INFORMATION BULLETIN

ISSUE DATE: October 17, 2006

RE: 625 One Touch leveling systems with remote rocker switches

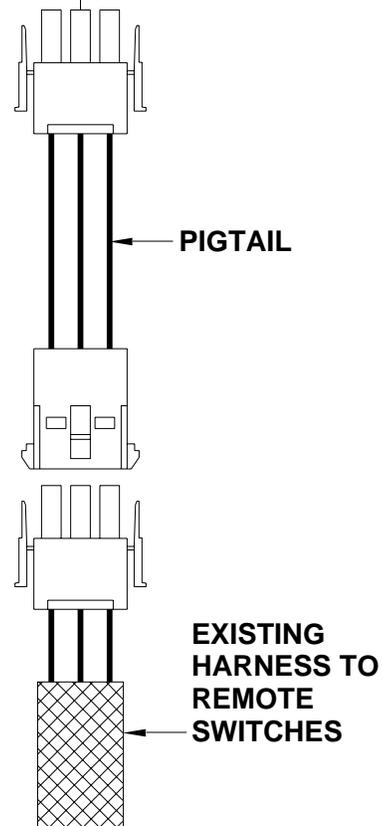
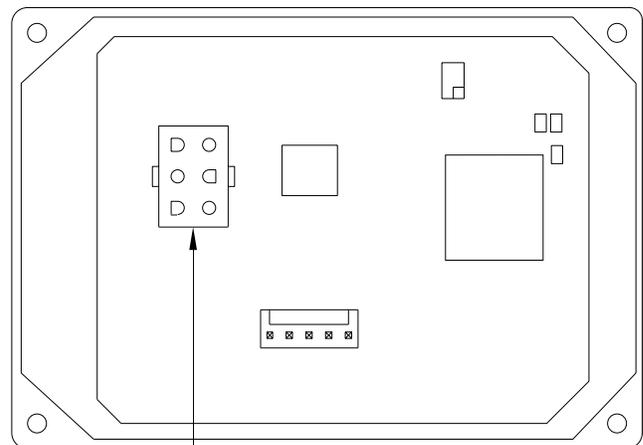
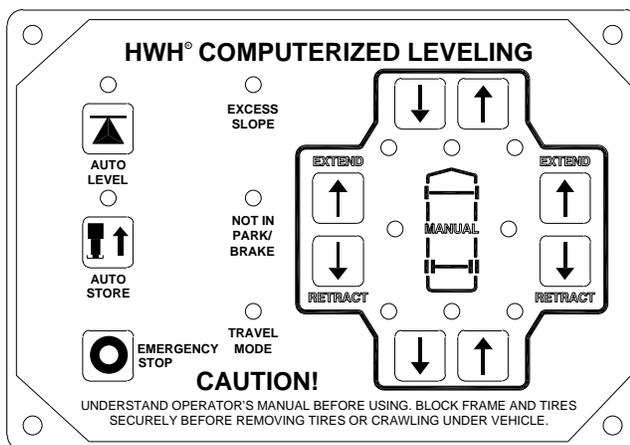
Some One Touch leveling systems with remote rocker switches may experience the leveling system shutting off during an Auto Level or Store sequence. The addition of this pigtail will update the system to rectify this issue. (Pigtail update kit - RAP91993)

Unplug existing harness and insert pigtail between Touch Panel end existing harness.
